**TSG-RAN Meeting #7
Madrid, Spain, 13 – 15 March 2000**

Title: Agreed CRs to TS 25.113

Spec	CR	Rev	Phas	Subject	Cat	Current	New	WG4 doc
25.113	001		R99	Corrections to TS 25.113	F	3.0.0	3.1.0	R4-000025
25.113	002		R99	Definitions for TS 25.113	F	3.0.0	3.1.0	R4-000058
25.113	003		R99	Corrections and additions to TS 25.113	F	3.0.0	3.1.0	R4-000129

25.113 CR 001

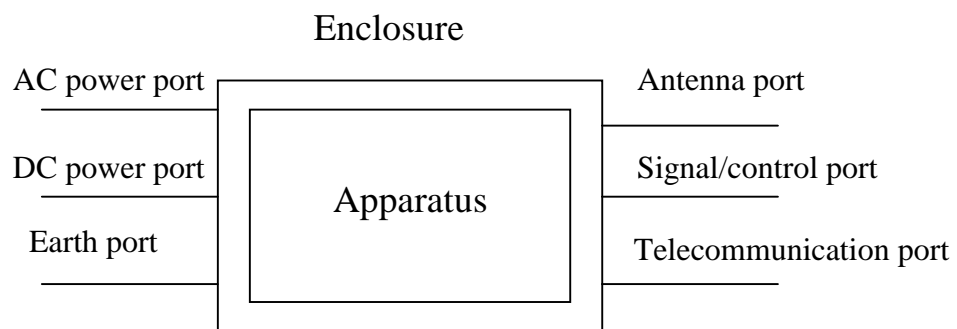
Port: A particular interface, of the specified equipment (apparatus), with the electromagnetic environment. For example, any connection point on an equipment intended for connection of cables to or from that equipment is considered as a port (see figure 1)
